**Re: Reevaluation Report
Norfolk Southern Railroad Crossing (S1B-0250)
Permit No. E65-973
Penn Borough, Jeanette, and Hempfield Townships, Westmoreland County**

In compliance with the Corrected Stipulated Order dated August 10, 2017 a Reevaluation Report on the above-referenced horizontal directional drill (“HDD”) was submitted to the Department on November 13, 2017. The Department requested more information on the Reevaluation Report by letter dated December 4, 2017, to which Sunoco Pipeline, LP (SPLP) provided a response on January 2, 2018. SPLP is in receipt of a second letter from the Department dated January 29, 2018 which requests further information and materials. Please accept this letter as a response. Your requests are bolded below followed by the response.

Attachment 2
Water Supply Illustration

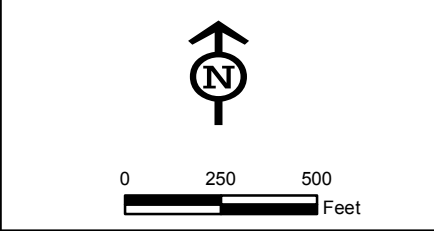
- 3. SPLP's response to Item 1.d. of DEP's December 4th letter referred to a water supply illustration, Attachment 2. Based on the illustration, there are a number of parcels identified within 450 feet of the HDD where public water supply was not confirmed and there is no indication of a private water well. Please provide information related to these parcels.**

Notwithstanding SPLP's effort to contact all landowners within 450 ft of the HDD profile, there are four (4) properties with individual residences where SPLP was unable to verify the source of water supply; however, each of these locations adjoins residences where public water supply has been verified. Accordingly, it is reasonable to conclude that these residences are also served by public water.
